# TOLEDO-LUCAS COUNTY PLAN COMMISSIONS

REF: SUP-1004-19

SUBJECT: Request for an Amendment to Special Use Permit for gas station & convenience store at 3023 Dorr Street.

# SITE PLAN

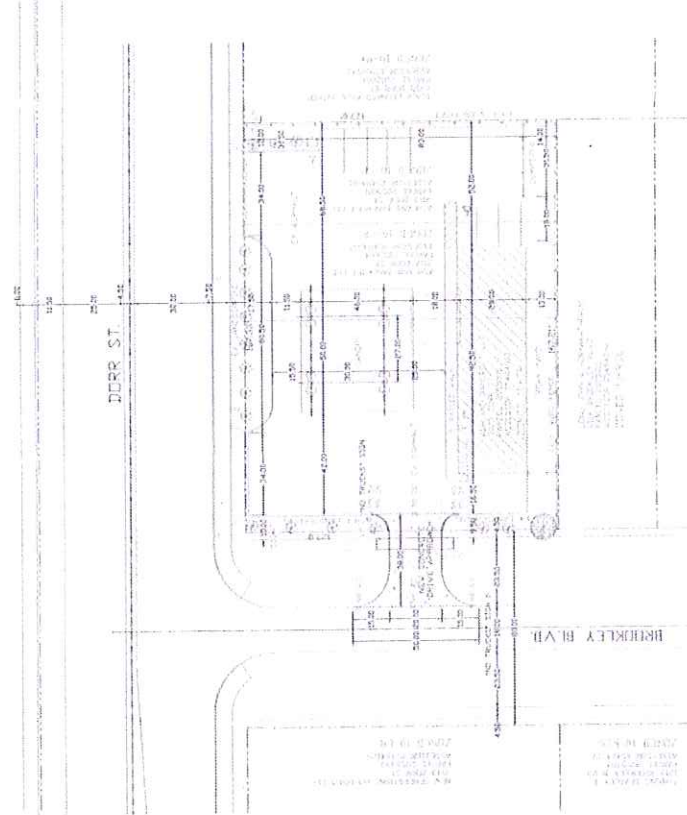
The submitted site plan did not include landscaping improvements or adequately comply with the original approval and therefore not acceptable. A revised landscaping plan shall be submitted depicting plantings per the approved plan and/or compliance with TMC§1108.0200 and listed as a condition of approval.

5. Brookley Blvd is an unimproved, uncurbed street. There is no formal gutter flow line; stormwater drainage flows down the street at the edge of pavement (EOP). A new drive approach on an unimproved street could impede the drainage flow path at the EOP and create a nuisance of stagnant backed up storm drainage. To minimize the chance of creating this condition, be aware that the approach detail showing a raised lip for the concrete approach at the EOP is not required. Rather, the concrete at the EOP can be flush or even set lower compared to the asphalt.

6. Flow at the EOP appears to flow from south to north, from the 98.83 elevation at the southwest corner of the proposed drive approach to the 98.62 elevation at the northwest. The 98.40 elevation in between means that a 2" deep puddle will result in the middle of the approach. Resubmit a minor revision to Engineering Services that shows grading for positive flow across the approach.
7. A catch basin (CB) exists at the corner of Dorr and Brookley. Consider extending a new storm line, or a perforated underdrain from the CB to the south limit of the proposed drive approach to provide drainage for any impounded water that forms there. If such work is added to the project, submit permit drawings for approval to the stormwater engineer.
8. Owner may be required to remove and reinstall the drive approach if nuisance drainage condition results from inattention to above drainage concerns.

17. New driveway needs to be a minimum of 25 feet wide to facilitate two-way traffic per TMC 1107.

18. The right-of-way encroachment permit will not be issued until landscaping has been installed per the original Special Use Permit (*Ord. 684-02*).
19. All lots of the development site shall be combined into a single taxable parcel identification number.
20. All parking spaces reserved for use by persons with physical disabilities shall adhere to the standards outlined in TMC§1107.1700; **acceptable as depicted on site plan.**
21. Bicycle parking slots shall be provided pursuant to Off-Street Parking Schedule "A" (TMC§1107.0300), which requires one (1) bicycle parking slot per ten (10) parking spaces. **A minimum of two (2) bicycle spaces shall be provided and depicted on a revised site plan.**
